APPLICATION NO.	FILING DATE	FIRST NAMED INVENTOR	ATTORNEY DOCKET NO.	CONFIRMATION NO.
09/989,271	11/20/2001	Michael C. Smyk	FCI-2632/C3069	9590

Office Action Summary	Application No.	Applicant(s)
	09/989,271	SMYK, MICHAEL C.
	Examiner	Art Unit
	James R. Harvey	2833

DETAILED ACTION

FIG. 21

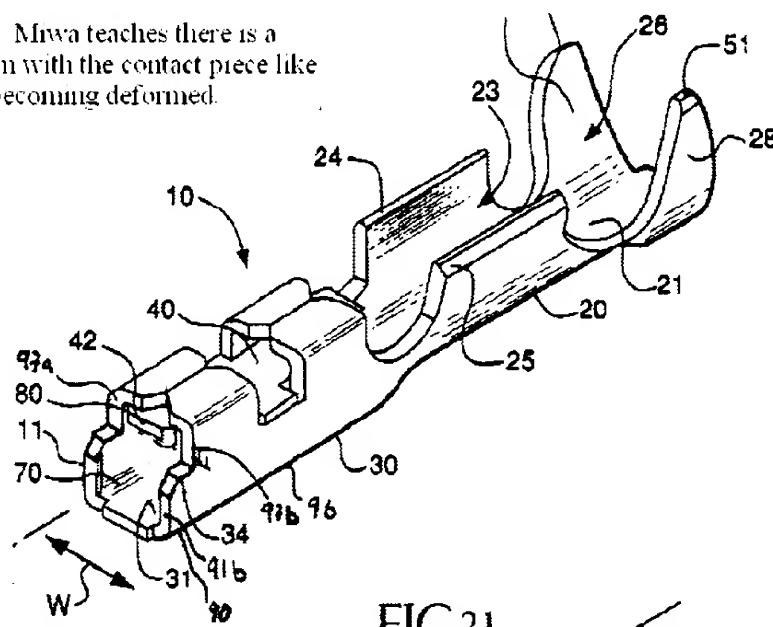
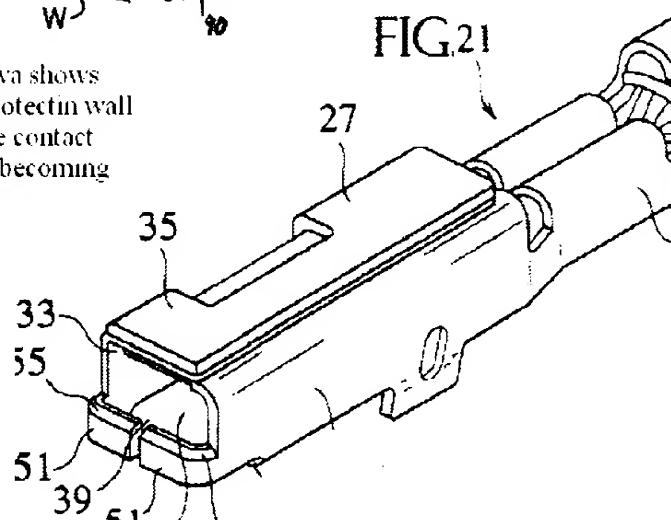
Step 1: Miwa teaches there is a problem with the contact piece like FCT's becoming deformed.

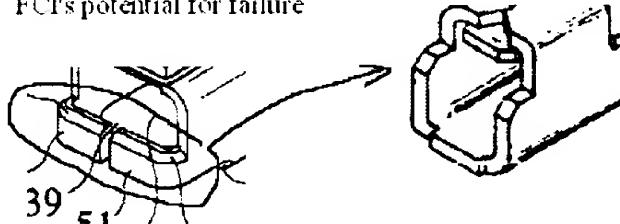
Step 2: Miwa shows putting a protective wall prevents the contact piece from becoming deformed.

Step 3: One skilled in the art uses the teaching of Miwa to reduce FCT's potential for failure

Step 4: All limitations of Claims 22-42 are shown in the Miwa's improvements to FCT's terminal.
